Location:	South of Astro Drive
APN:	008-521-54, -55, -89, 90, 008-522-16, -18, 008-531-59, -60
Master Plan Designation:	Mixed Use Residential
Zoning:	General Industrial (GI)
Parcel size:	112.69 acres
Subject:	CSM-18-035: Plateau

PROJECT DESCRIPTION: A Conceptual Subdivision Map for 339 single family lots on 81 acres, an 11 acre multi-family development, 3 acres of General Commercial, and 17 acres of open space.

The following is a summary of the comments you received at the Conceptual Review meeting held on March 20, 2018 regarding Plateau.

Fig
ES-3

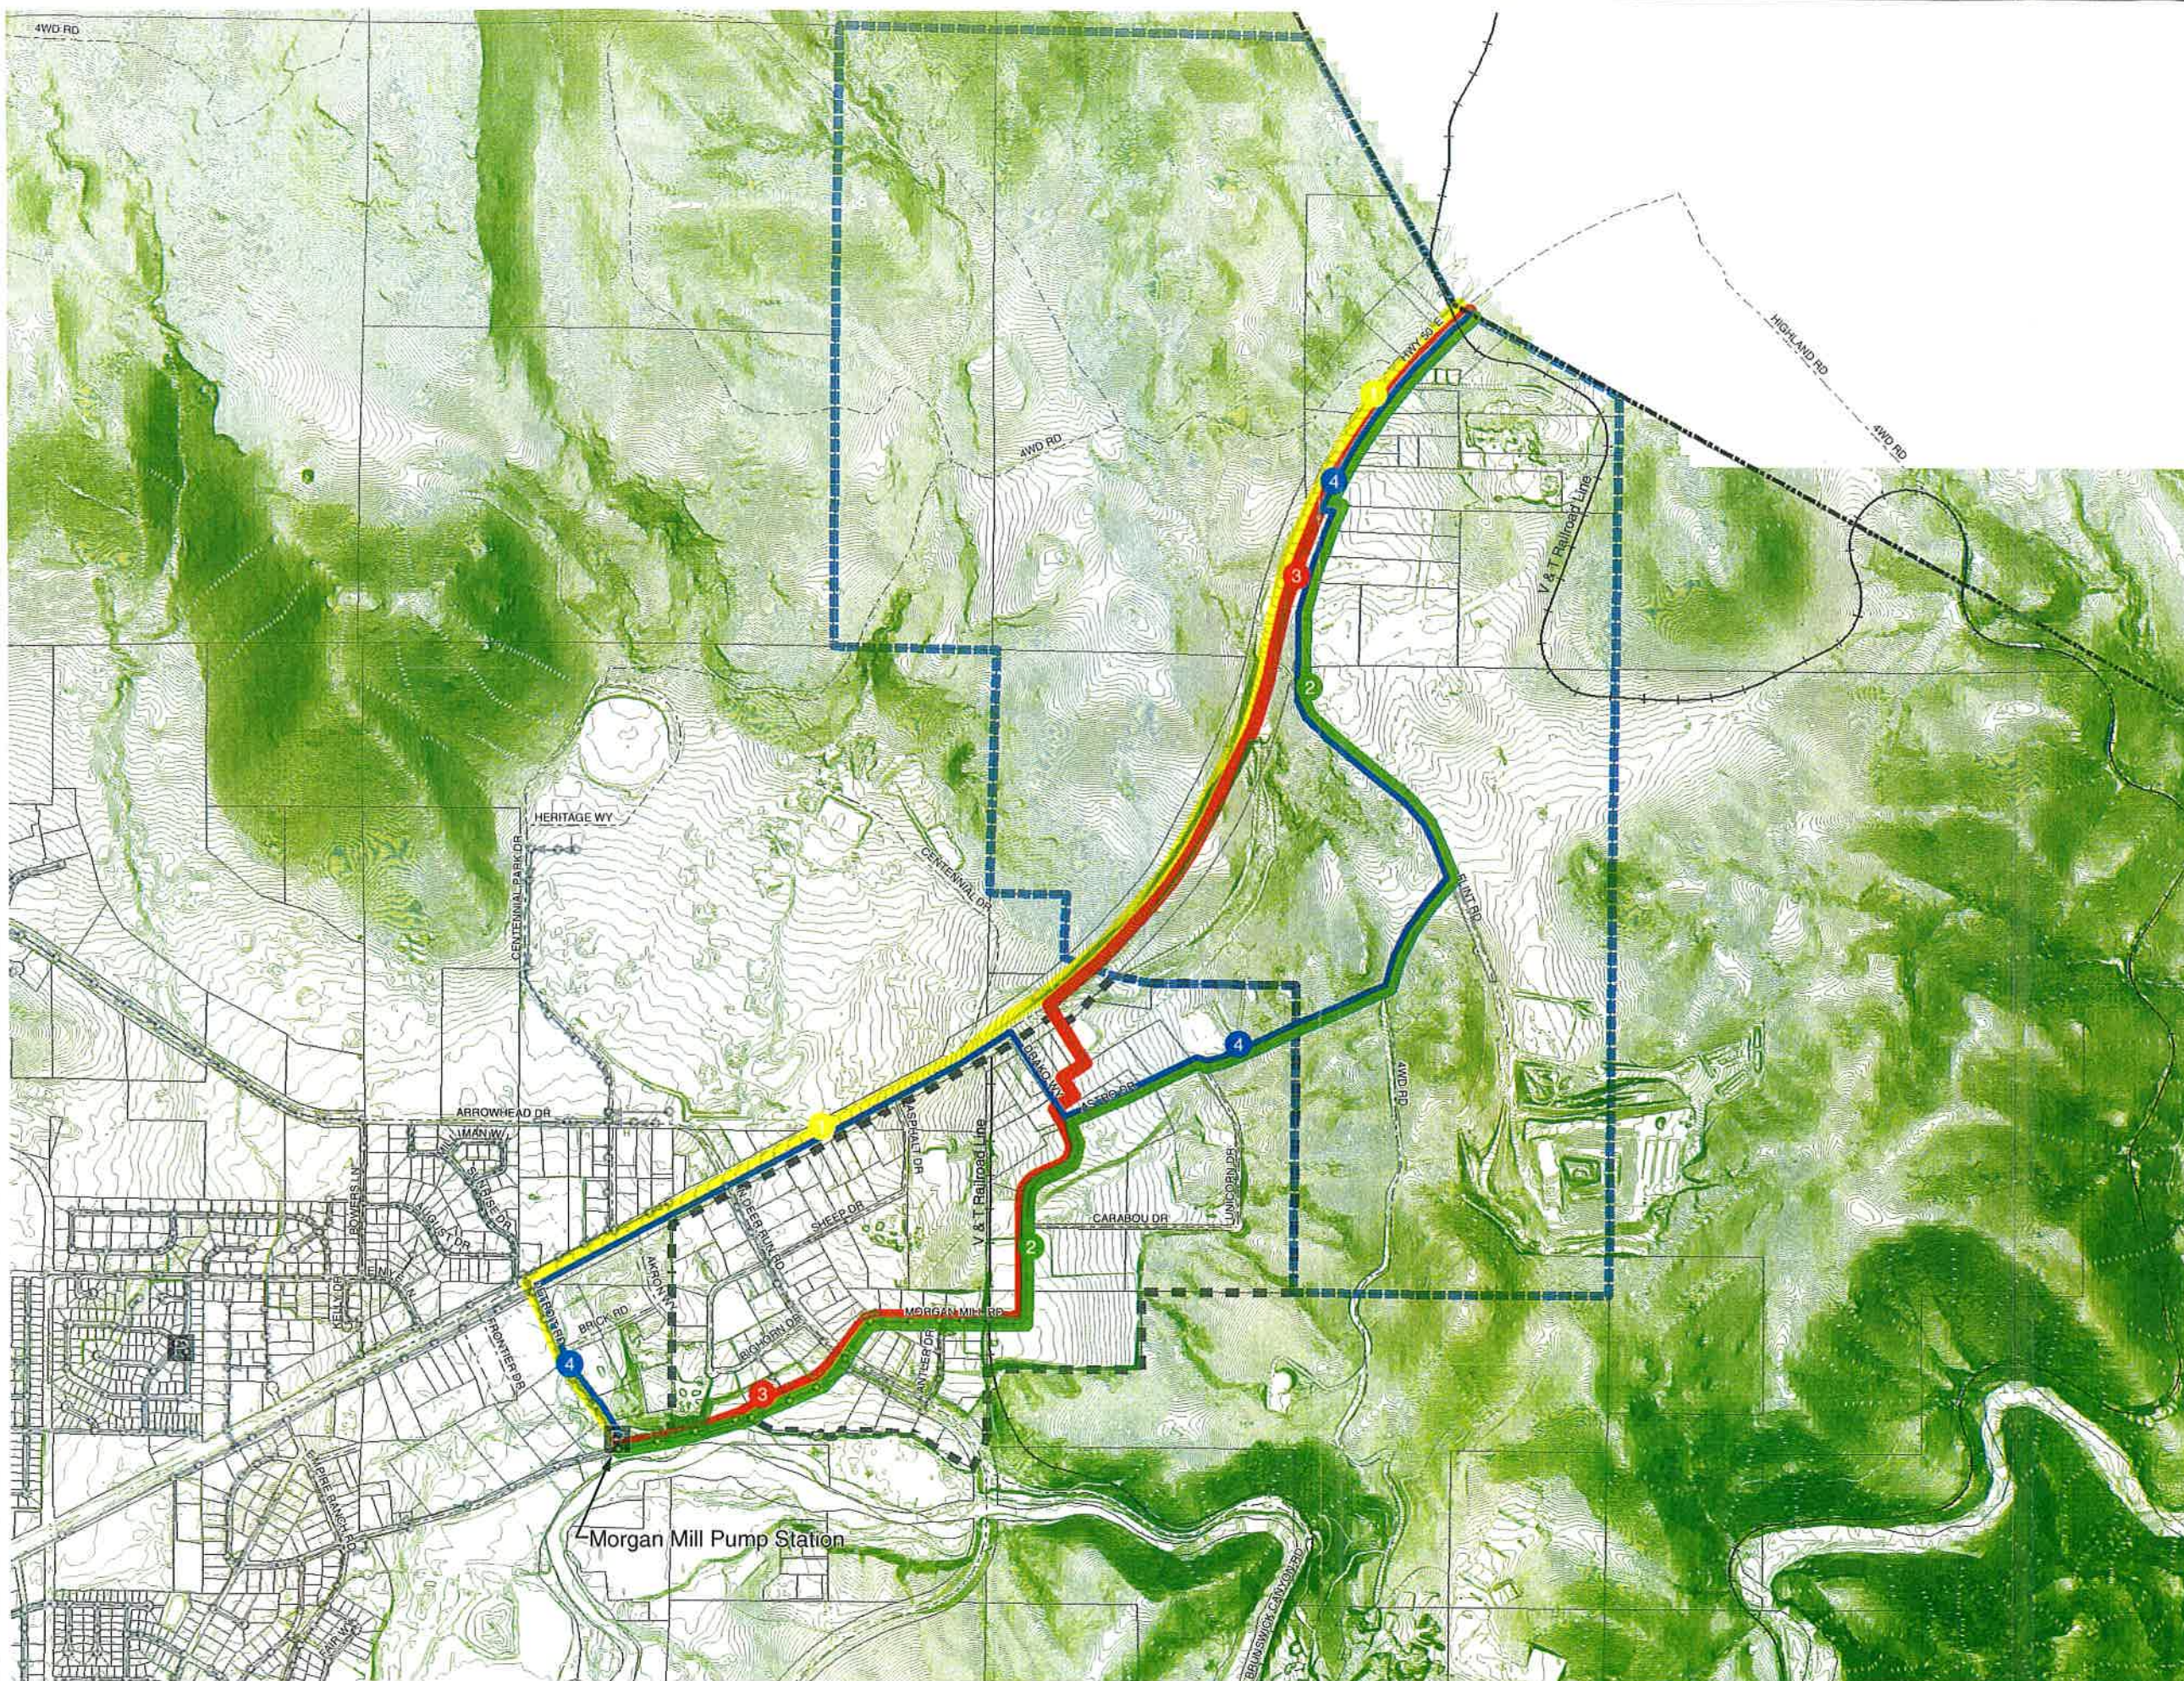
As indicated on Figure ES-3 from the referenced Study, several Sanitary Sewer Routing Alternatives were considered to provide service for properties located within the the "Northeast Service Area" as identified in that Study. Please also note that in addition to the private parcels located in that "North East Service Area," the proposed VTRW Eastgate Station Expansion is also located within this area. All of these properties will ultimately require Sanitary Sewer and Water service to accommodate future development.
